Planning Committee

Application	Proposal	Page
6.	P17/V2884/FUL Land at Park Farm, East Challow	Variation of Conditions 9, 10, 11 and 15 and removal of Condition 8 of P16/V0652/O.	3 - 19

APPLICATION NO.	P17/V2884/FUL
APPLICATION TYPE	Full application
REGISTERED	19.10.2017
PARISH	East Challow
WARD MEMBER	Yvonne Constance
APPLICANT	Crest Nicolson
SITE	Land at Park Farm, East Challow
PROPOSAL	Variation of Conditions 9, 10, 11 and 15 and removal of Condition 8 of P16/V0652/O.
CONSULTATION EXPIRY	1 February 2018
OFFICER	Adrian Butler

DRAWING NUMBER: **VD17541-SK21** REVISION: **A**

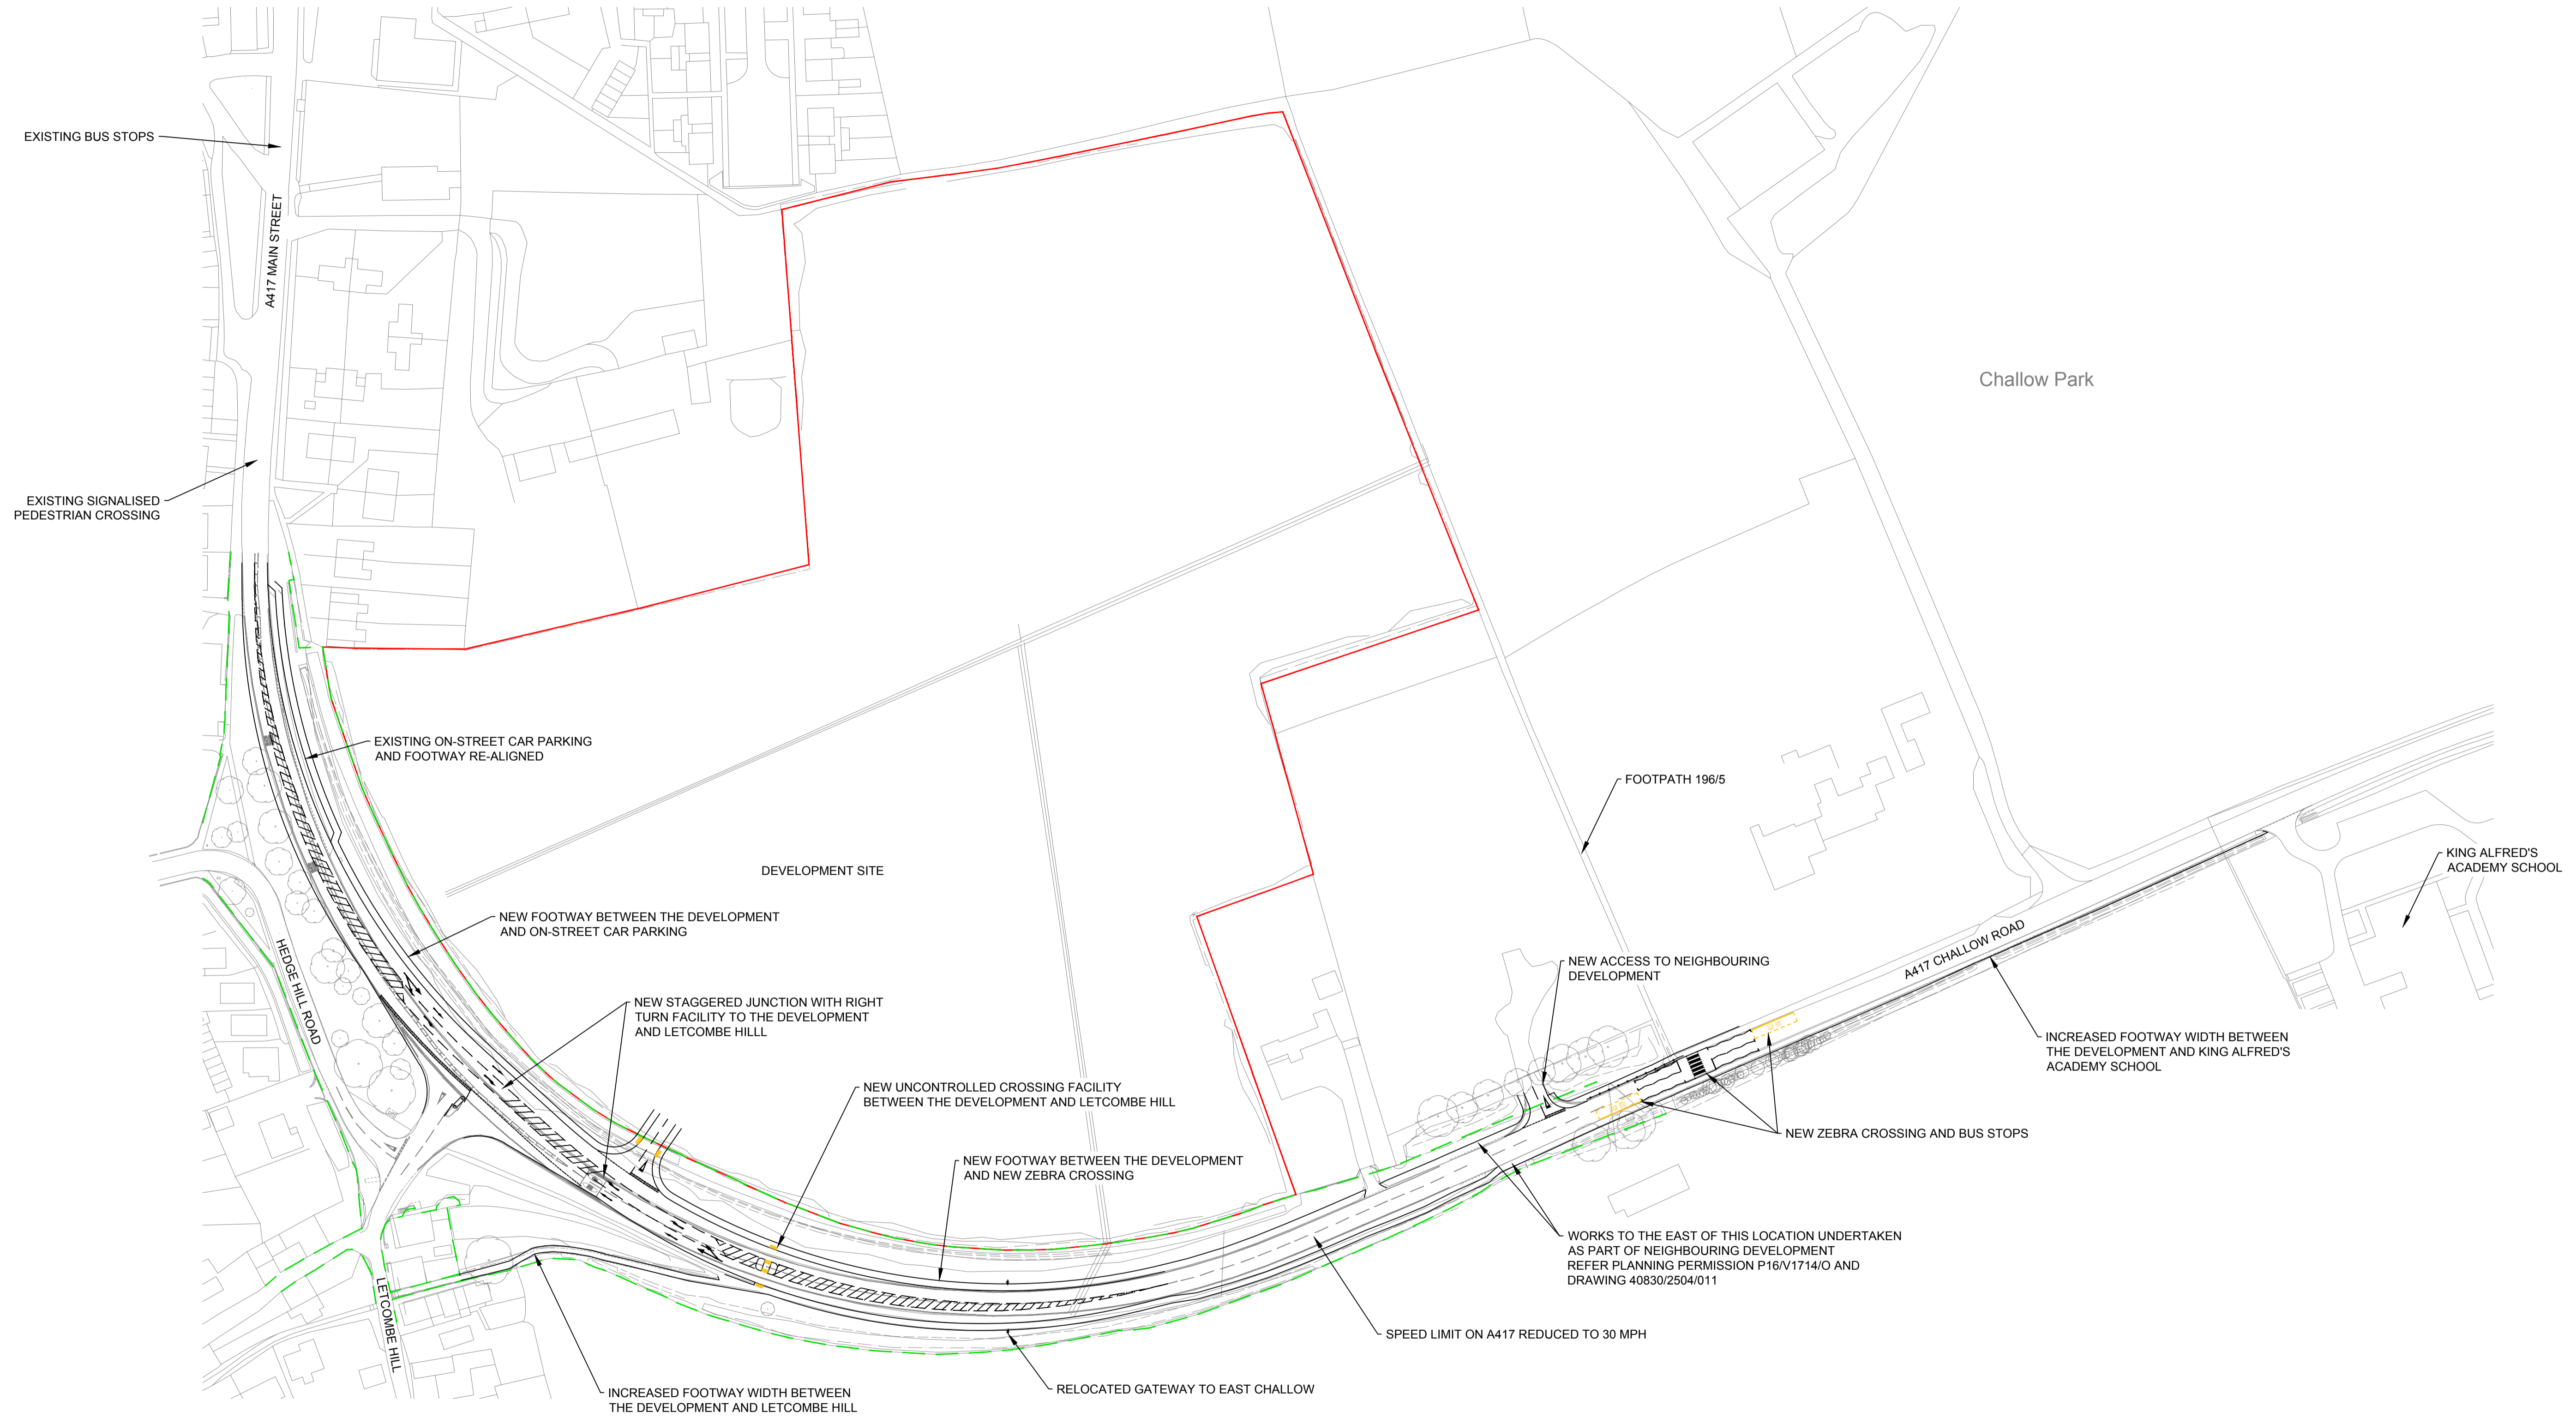
- 1.8 Conditions 10 and 11 require details of a proposed roundabout on the A417 at the site entrance plus visibility splays to be agreed. The application seeks permission to replace the roundabout with a priority junction instead. The priority junction comprises road widening to form ghost right hand turn lanes into the development site and to Letcombe Hill. A plan of the junction is **attached** as Appendix 1.

<p>Oxfordshire County Council</p>	<p>Amended Plans Highways No objection The applicant’s technical note has been reviewed:</p> <ul style="list-style-type: none"> • The design of the works on A417 will exclude the use of red coloured High Friction Surfacing • The design of the works on A417 will avoid the use of 7% superelevation on the A417 carriageway • The updated design drawings are provided as Drawing no VD17541-SK21 Rev A and Drawing no VD17541-SK22 Rev B.

5.4 The outline application for the up to 88 dwelling proposal (P17/V0652/FUL) was approved by planning committee at its meeting on 8 June 2016. In paragraph 6.44 of my report to that planning committee I advised: *"The roundabout is not essential and access could be provided by a right hand turn lane located to the north or east, although locating it to the north would result in the loss of some needed, existing parking adjacent to the A417"*. A roundabout serving this site is not essential.

- Average vehicle speeds are 30mph, with 85th percentile (design) speeds at 34mph
- There is some short-term queueing on the east bound A417 due to traffic turning into Letcombe Hill blocking through traffic.

Queueing on the A417 will be limited as a right turn lane will be provided for vehicles turning into Letcombe Hill (the right hand turn lanes are some 40m long and could provide space for at least six vehicles seeking to turn right).

- Queuing on Letcombe Hill occurs due to traffic turning right on to the A417. The wait time is limited (photographic evidence in the submission shows a four vehicle queue clearing in some 19 seconds). This queuing has no impact on Hedge Hill Road as the maximum queue is one vehicle. The highway authority confirms in its response above that junctions are operating within capacity.

- Updated junction modelling using the industry standard PICADY software demonstrates that the proposed staggered crossroads will operate within capacity, with no significant queueing predicted. The highway authority confirms this in its response above.

- A sensitivity test has also been undertaken which confirms that the junction can accommodate a 10% increase in traffic flows whilst still operating within capacity (although this figure increases to 20% elsewhere in the technical note). At 10% there is still operational capacity, as confirmed by the highway authority.

- A road safety audit of the proposed pedestrian crossing facilities confirms that there are no road safety issues. This review has recommended that the existing gateway feature on entry to the village (which is to be relocated as part of the proposals) be enhanced to reinforce vehicle speeds on approach to the crossing. This will be incorporated into the detailed design of the proposals and a suitable gateway feature agreed with Oxfordshire County Council as part of the detailed design of the highway works. The pedestrian crossing refuges can accommodate a wheelchair.

Prior to the first occupation of any dwelling full details of the proposed staggered priority junction and other associated works, including appearance and pedestrian

crossing points shall be submitted to and approved in writing by the local planning authority. The details shall be substantially in accordance with drawings VD17541-SK24, VD17541 SK22 Rev B, VD17541 SK25 and VD17541-SK21 Rev A (unless agreed otherwise). The approved works shall be implemented prior to the occupation of the first dwelling on site.
